# DeKalb County Historic Preservation Commission

## Staff Report

H. 1458 North Decatur Road, Andrew Johnson. Replace rear deck. **1246872**

02-24 1458 North Decatur Road, Andrew Johnson. Replace rear deck. 1246872. **Partially Approved, Partially Deferred.**

① EXISTING FRONT ELEVATION SHOWING PROPOSED CHIMNEY AT REAR  
 1/4" = 1'-0" (NO DIRECT CHANGES TO FRONT FACADE)

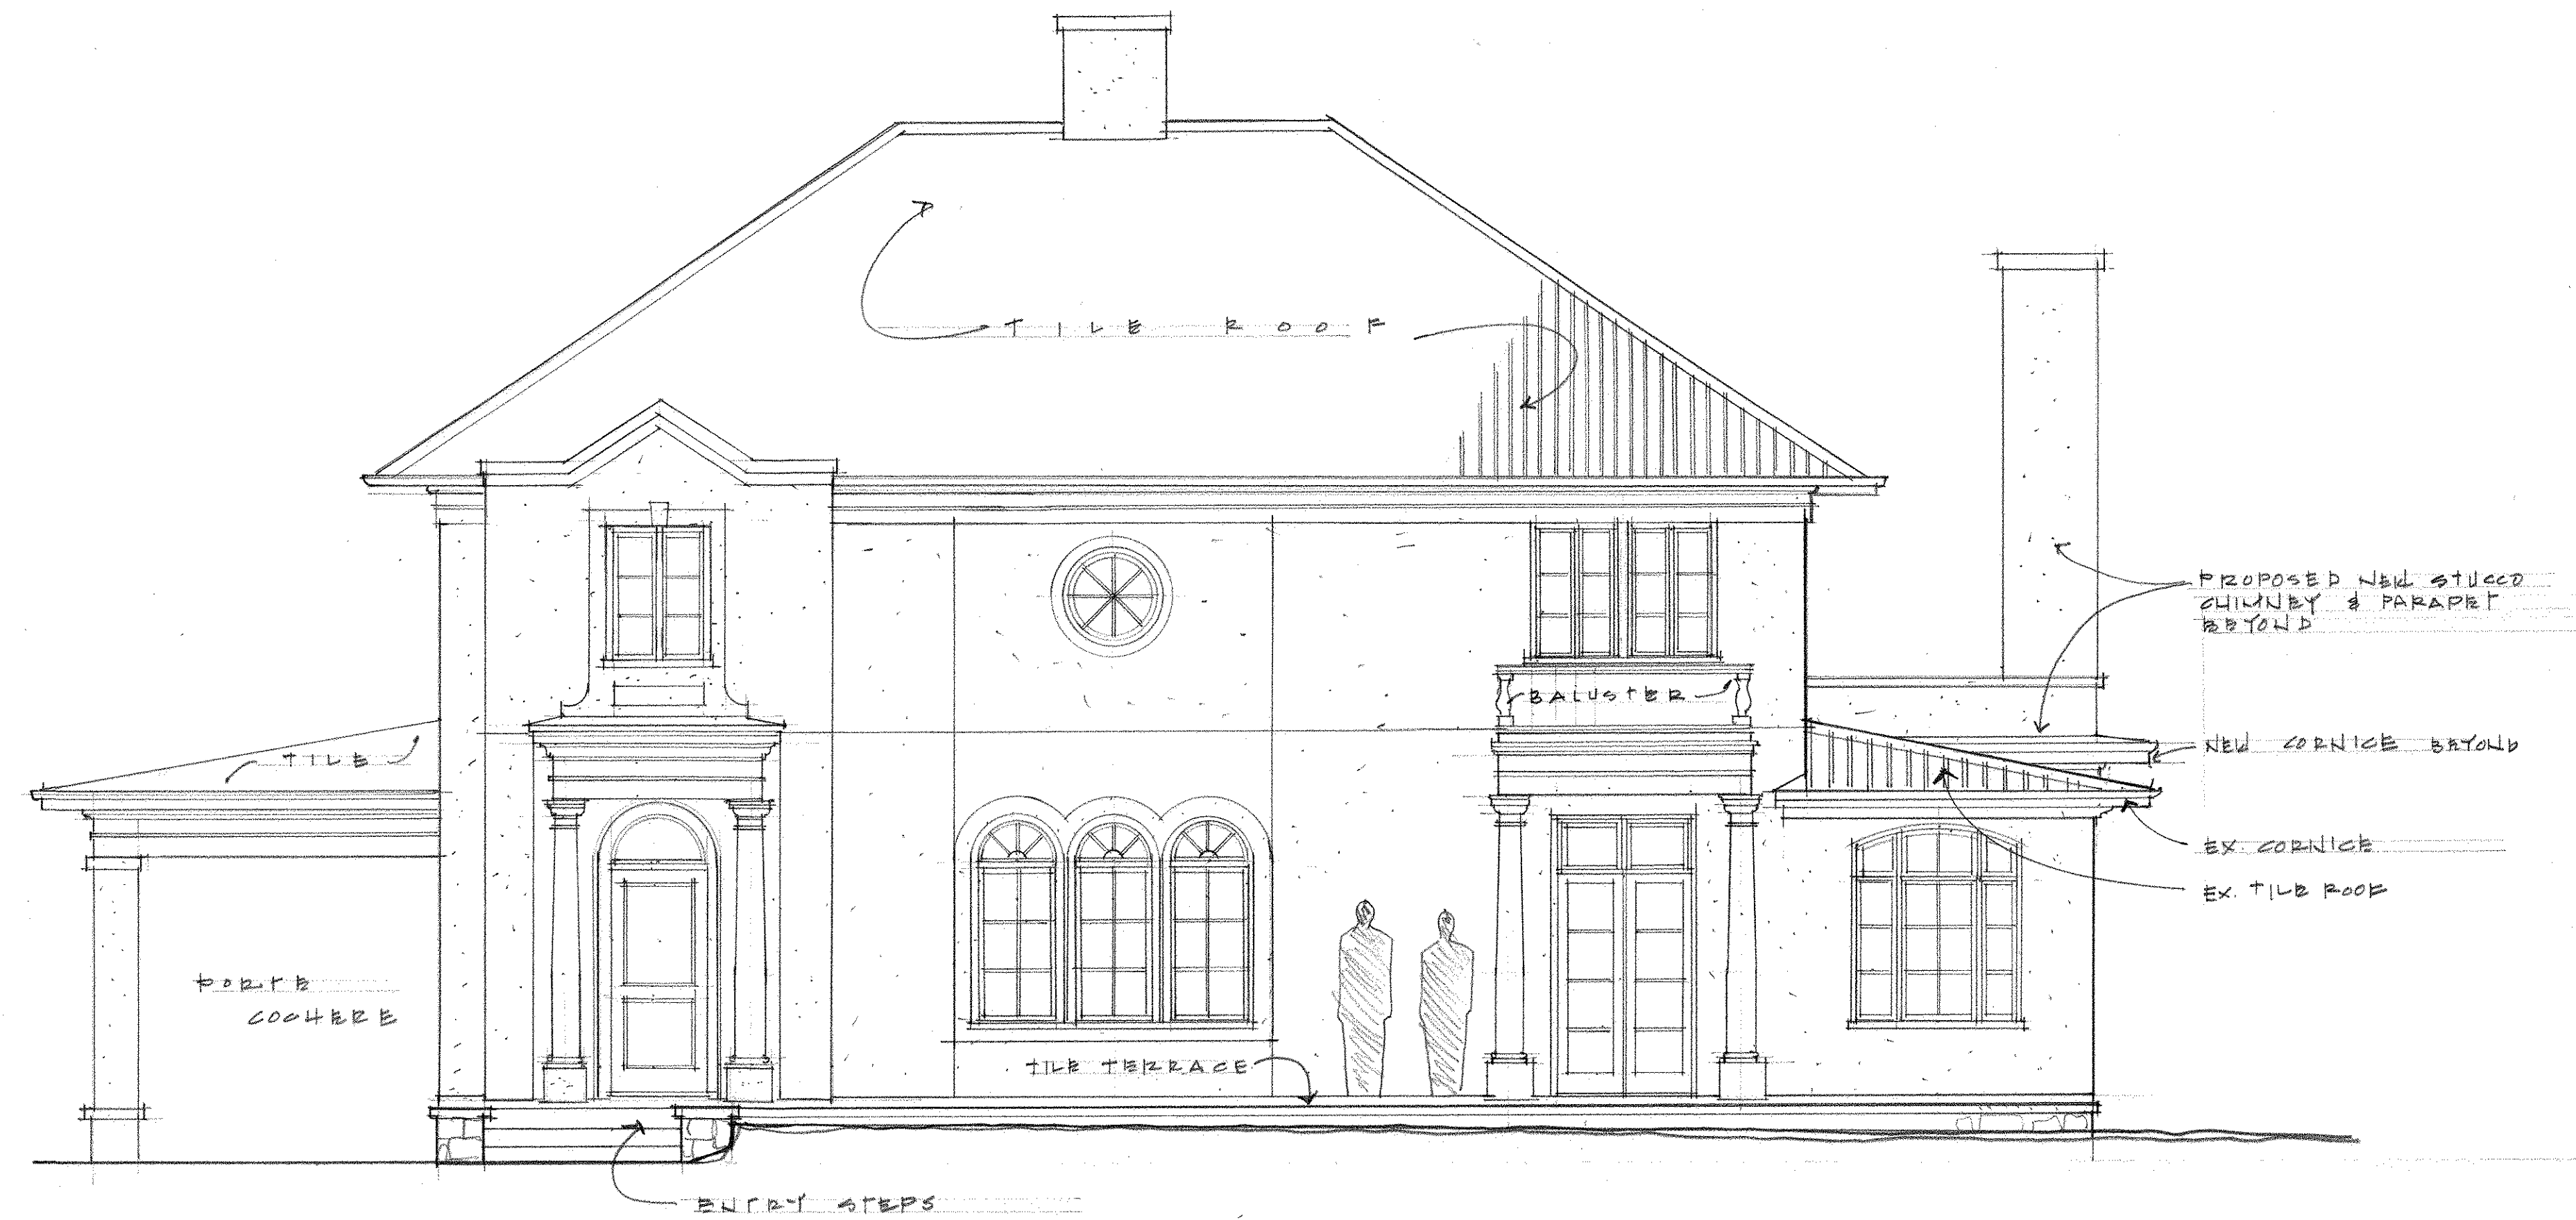
The applicant has submitted a new design for the previously deferred chimney element of the scope of work. The design proposes constructing a 3' 6" tall chimney on top of the roof of the approved enclosed deck. The chimney will be composed of a stucco base that matches the façade material of the home and a square termination metal cap.

Approve. The proposed changes do not appear to have a substantial adverse effect on the property or the district. This application appears to meet the guidelines and the staff recommends approval.

① EXISTING FRONT ELEVATION SHOWING PROPOSED CHIMNEY AT REAR  
 1/4" = 1'-0" (NO DIRECT CHANGES TO FRONT FACADE)

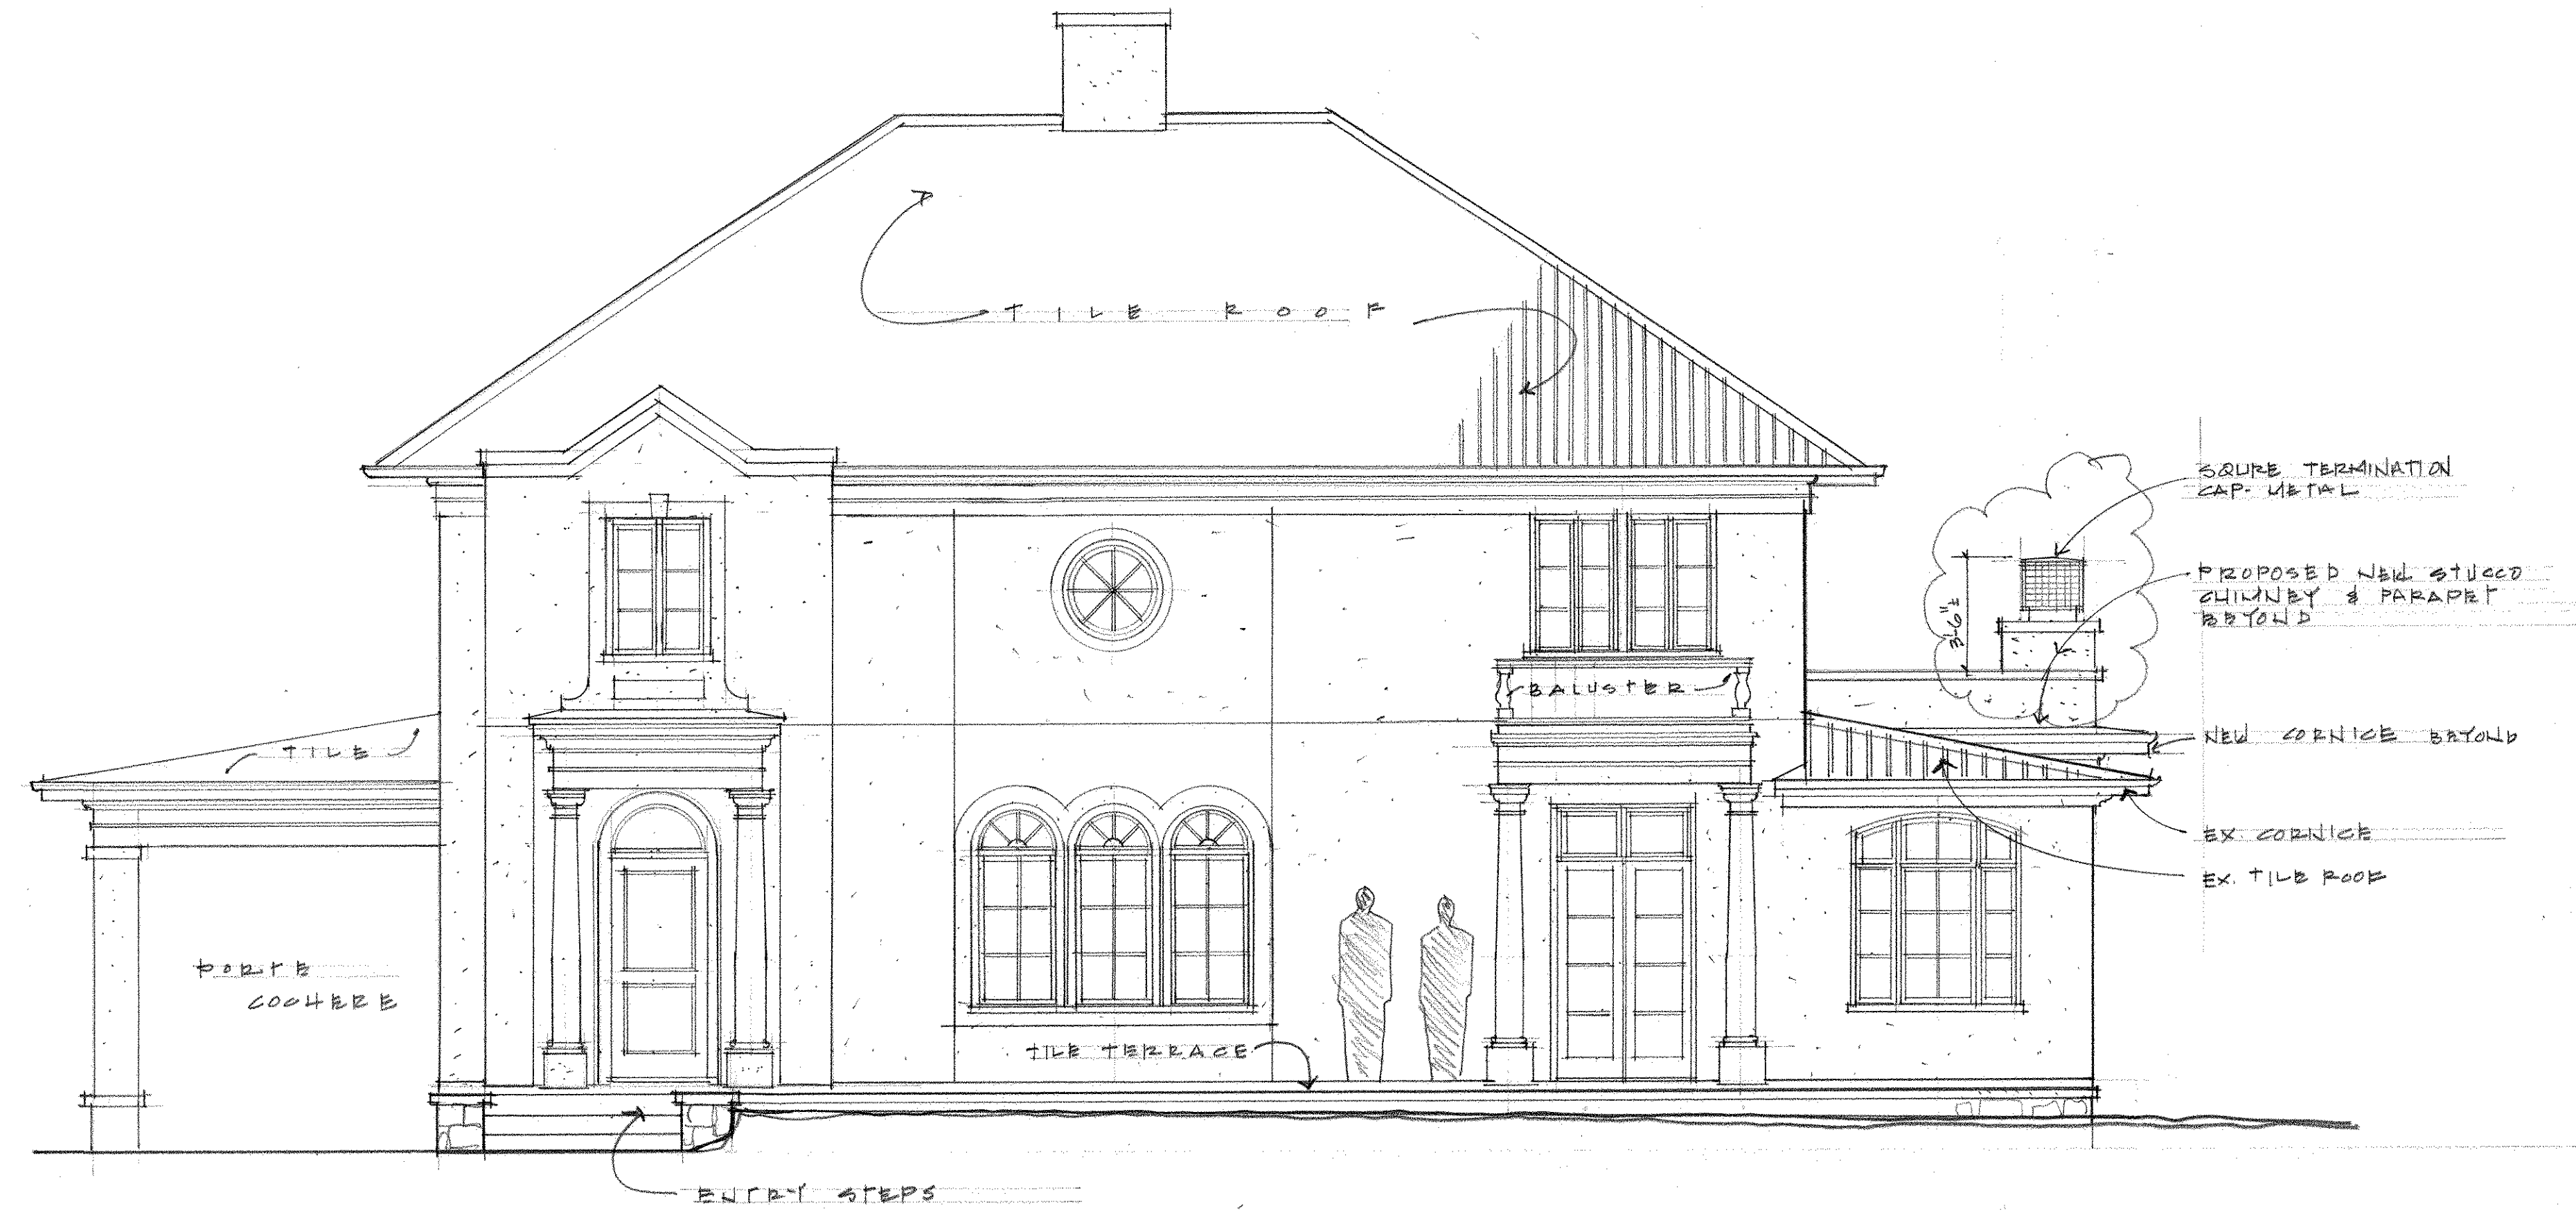
21 MARCH 2024  
 CHIMNEY REDLINE  
 IN HEIGHT
